Proposed Revisions to a Standard Plans Index

Index Number: 102-201

Index Title: TEMPORARY ACROW SERIES 700XS DETOUR
BRIDGE BEAM AND GUARDRAIL DETAILS

Sheet2: Updated guardrail backplate details to add clarifying information and remove errors.

THRIE BEAM TO BRIDGE GUARDRAIL TRANSITION

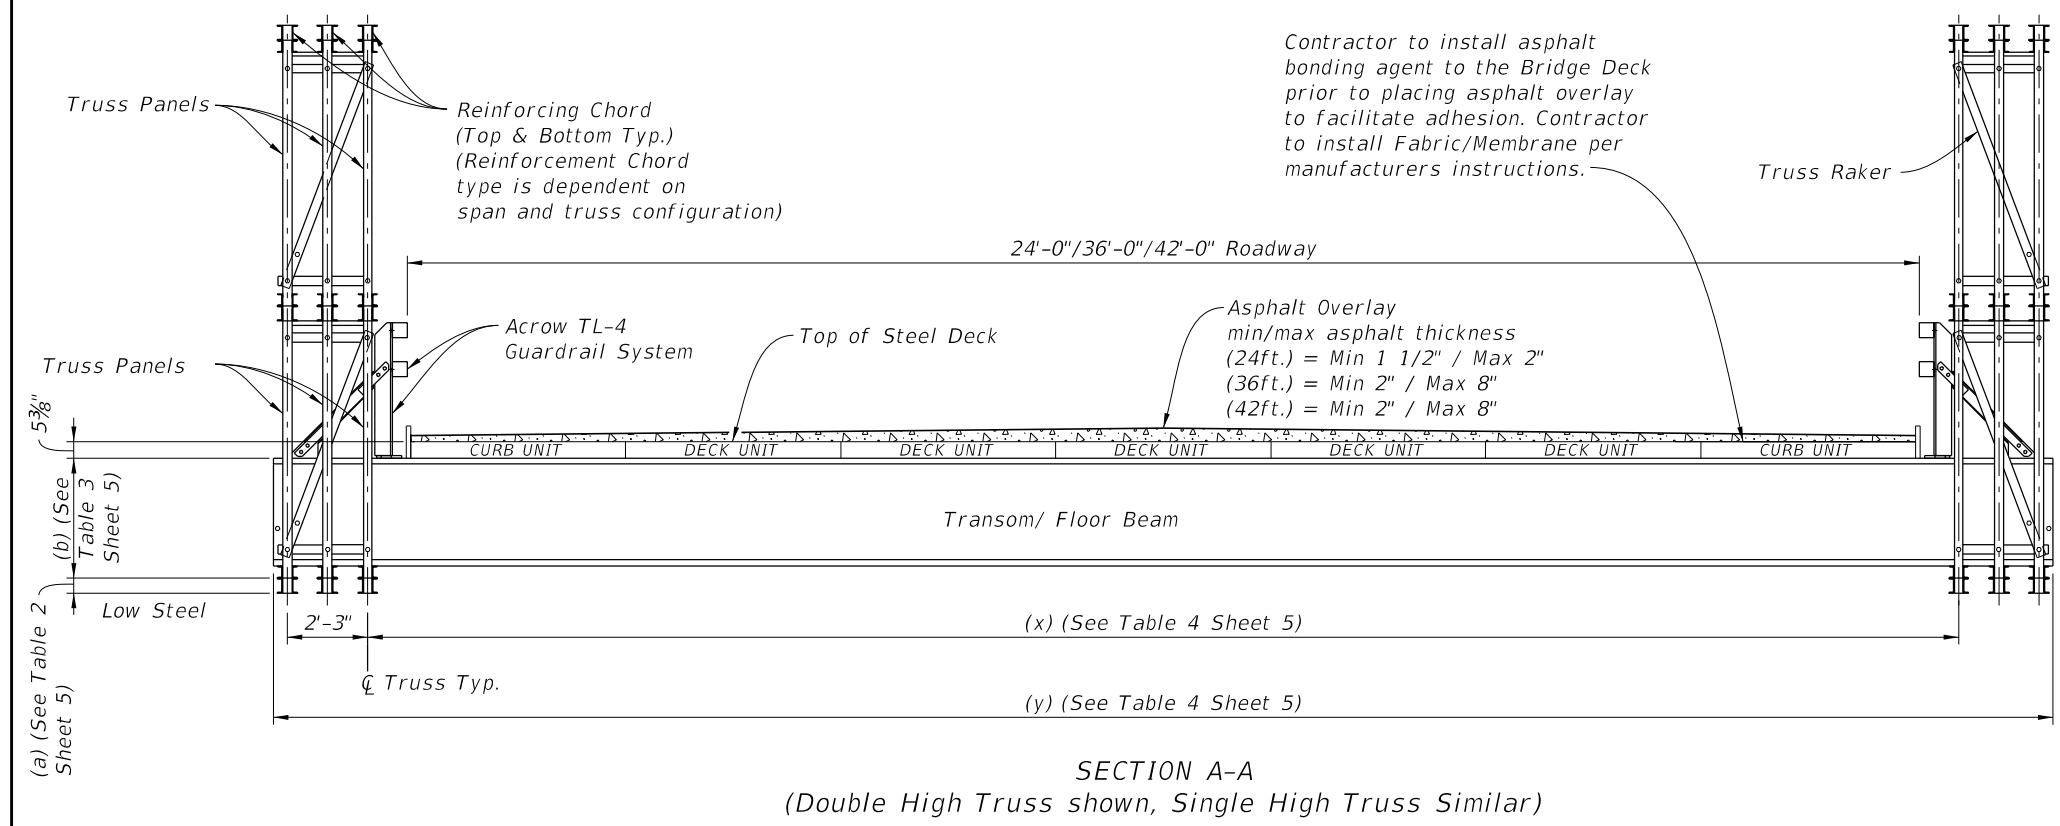
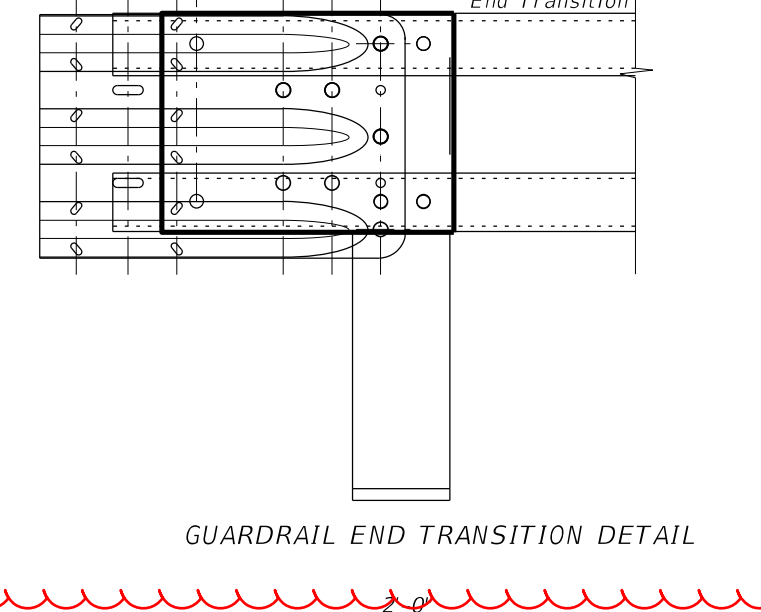
Updated drafting for clarity

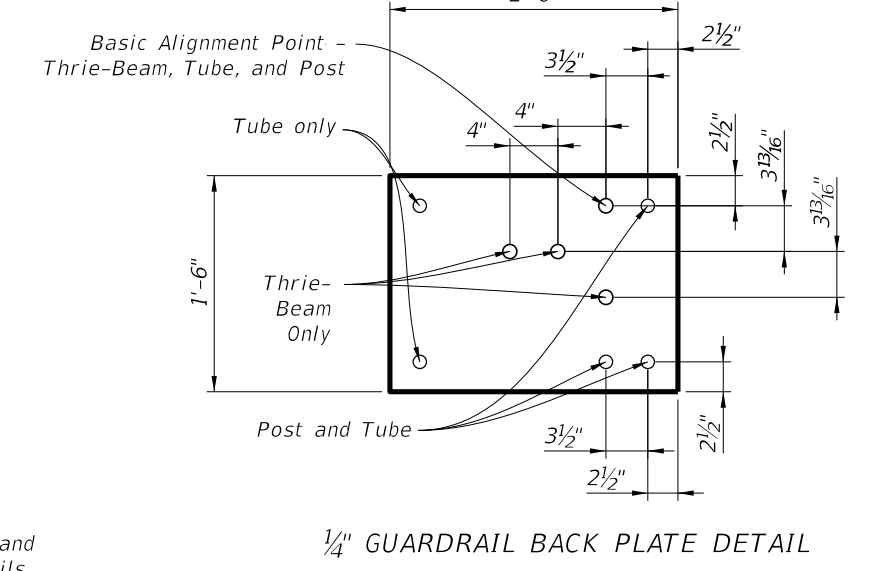
Added detail for further clarity
